Subject: Service Campaign ref.: L147.A-04.03
Wheel Bolt Replacement

Automobili
Lamborghini S.p.A.

Procedure: L147.A-04.03

Operation: Wheel Bolt Replacement

Fig. No. 1

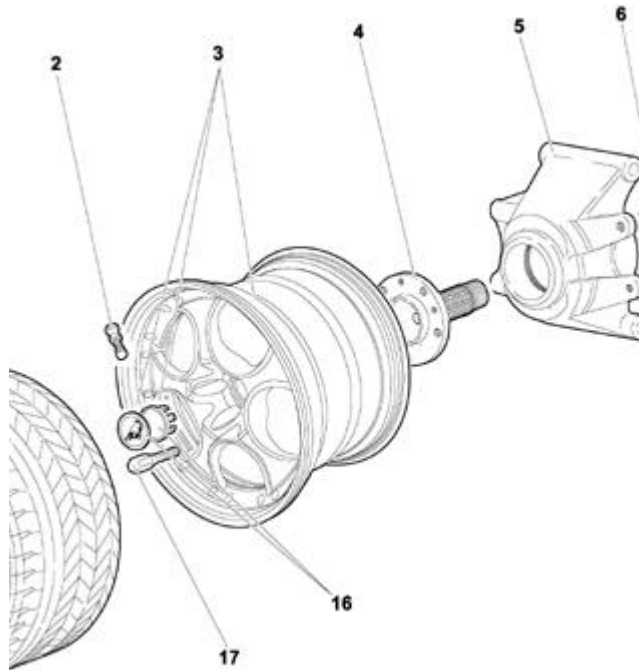
- 1.1 Remove the 5 wheel bolts P.N. 0052003030 (Fig. 1 Ref. 17) for each wheel.

- 1.2 Apply a light coating of anti-seize compound to the new wheel bolt threads and tighten to 140 Nm (103 ft.lbs.) using a properly calibrated torque wrench.
